Technical Service Bulletin (TSB)
Difficulty Fueling Fuel Tank

REFERENCE:	TSB: 14-009-26 GROUP: 14 - Fuel System	Date:	July 16, 2026	REVISION:	—
VEHICLES AFFECTED:	2026 - 2027 (B1) Jeep Renegade 2026 - 2027 (M1) Jeep Compass This bulletin applies to vehicles built on or after April 06, 2026 (MDH 0406XX) and on or before April 11, 2026 (MDH 0411XX).			MARKET APPLICABILITY: ☐ NA☐ MEA ☒ SA☐ IAP ☐ EE☐ CH NOTE: This bulletin applies to the South America market.	
CUSTOMER SYMPTOM:	Customers may experience the following: ● Difficulty fueling the vehicle.				
CAUSE:	Inflow control valve

Fig. 1
Fuel Tank Assembly

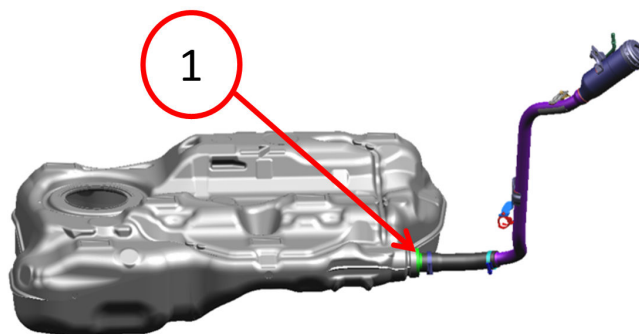
1. Open the fuel fill door.
2. Insert a borescope probe through the filler neck and attempt to open the inflow control valve [Fig. 1](#) using the end of the borescope.

3. Was the inflow control valve operational?
 - YES >>> This bulletin has been completed. Use Inspect LOP (14-60-01-9P) to close the active RSU.
 - NO >>> The inflow control valve is stuck. Proceed to [Step 4](#).
4. Replace the fuel tank. Refer to the detailed service procedures available in DealerCONNECT/Service Library under: Service Info> 1040A10 - Reservatorio de combustivel - remocao/recolocacao e transferencia de combustivel . incluso procedimientos necesarios.
